# Access Compliance Report

## Public Rights-of-Way

### (Curb Ramps)

Intersection ID: 5317	Main Street: OLD_STATESVILLE_RD	Cross Street: OAK_DR	Location:	N
ADA ID: DFB5AD1AD80D	Ramp Type: Perp	Initial Pass/Fail: Fail	Overall Compliance: No	Severity Score: 8.75
Codes/Mitigation Info/Possible Solution		Field Measurements/Component Compliance

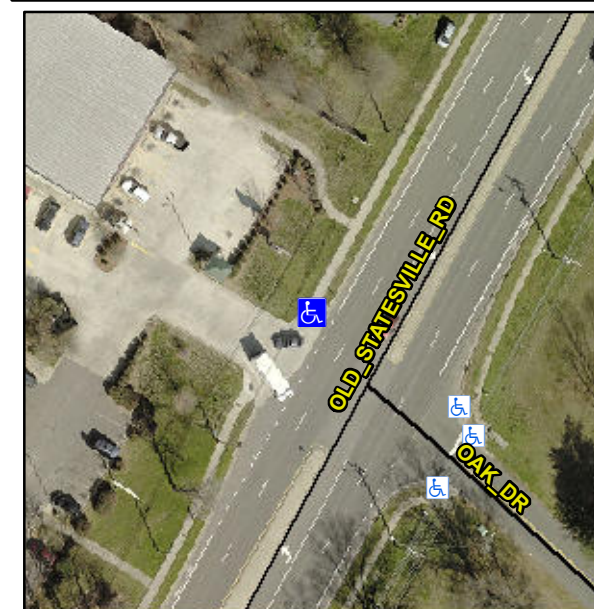
**R304.5.1**

Compliance	Description	Data	Compliance	Description	Data
N/A	Ramp Length (in)	56.5	Yes	Ramp Slope (%)	7.7
No	Ramp Width (in)	47.0	Yes	Ramp XSlope (%)	1.2
N/A	Flare Type LT	N/A	N/A	Flare Type RT	N/A
N/A	Flare Slope LT (%)	N/A	N/A	Flare Slope RT (%)	N/A
N/A	Flare Traversable LT?	N/A	N/A	Flare Traversable RT?	N/A
N/A	Landing Length (in)	N/A	N/A	DWS Provided?	N/A
N/A	Landing Width (in)	N/A	N/A	DWS Contrast?	N/A
N/A	Landing Slope (%)	N/A	N/A	DWS Length (in)	N/A
N/A	Landing X Slope (%)	N/A	N/A	DWS Full Width?	N/A
N/A	Landing Curb? (Y/N)	N/A	N/A	DWS Offset (in)	N/A
N/A	Shared Landing?	N/A			
N/A	Gutter Ponding?	N/A	N/A	Gutter Slope (%)	N/A
N/A	Gutter Lip Ht (in)	N/A	N/A	Gutter X Slope (%)	N/A
N/A	Painted X Walk1?	No	N/A	Painted X Walk2?	N/A
	X Walk 1 Direction	To E		X Walk 2 Direction	N/A
N/A	X Walk 1 Width (in)	N/A	N/A	X Walk 2 Width (in)	N/A
	X Walk 1 Slope (%)	0.4		X Walk 2 Slope (%)	N/A
	X Walk 1 X Slope (%)	0.6		X Walk 2 X Slope (%)	N/A

**Remove & Replace Entire Ramp.**
